Task Order 22: Engineering and Technical Support Deep Bore Hole Field Test

Task Order 22 - Engineering and Technical Support, Deep Borehole Field Test: AREVA Summary Review Report, AREVA RPT-3014934-000

The scope of this report is to provide a summary review of the “Deep Borehole Field Test Specifications/M2FT-15SN0817091” Rev 1 [1], herein referred as the “M2 report,” as prepared by SNL. The purpose of this SRR is to provide an evaluation of the conceptual design of the WP borehole emplacement systems (i.e., emplacement mode, WP design, etc.) presented within the M2 report and either concur with the identified recommendation on the preferred emplacement system in the report or identify an appropriate alternative(s).

FIGURE 4-1: IMPACT LIMITER STROKE

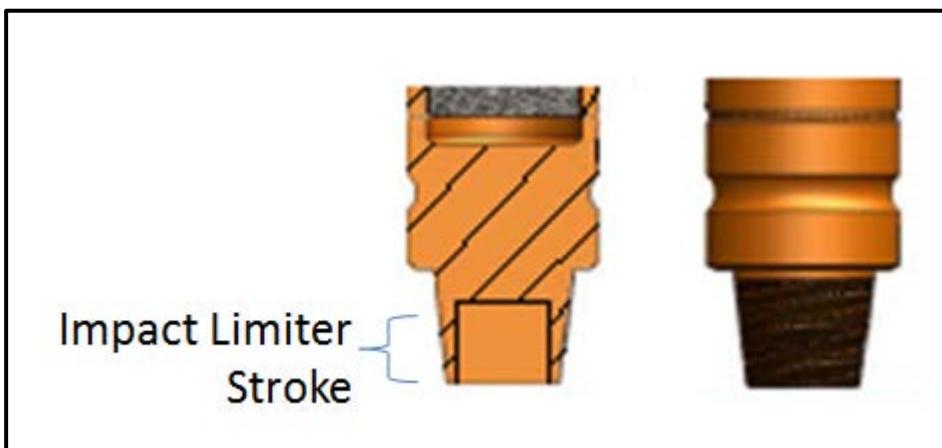
The required crushing stroke of an IL is evaluated in Section 4.3 of the M2 report. The calculation is based on a linear energy-balance using the terminal velocity listed in Section 4.2 of the M2 report. The IL is assumed to be used for a single package inserted by wireline.

- It is recommended that requirements be added for the IL to define its function. These requirements could include: the IL shall not prevent retrieval of the package below it (the IL should not deform the lift point below it excessively), the IL should not expand radially to fill the casing, and the IL needs to perform in and out of the borehole (be able to function in air or in an emplacement fluid environment).

The maximum weight (static) the package could see is 468,000 lbs (per Section 2.6.4 of the M2 report). This means that the onset of elastic buckling would occur if the g-level exceeded 2.1 g assuming a dynamic amplification factor (DAF) of 2.0 (very rigid system per NUREG-3966 [15]) and no safety factor to elastic buckling. If there were no IL, the lower end of the WP (impacting end) would be a solid steel surface with approximately 6-in diameter (scaled from Figure 2-14 of the M2 report). Assuming that the steel would flow at a stress just above yield and not work harden (120 ksi) and applying the combined weight of the WPs and the drill pipe, a g level of 7.2 g would result.
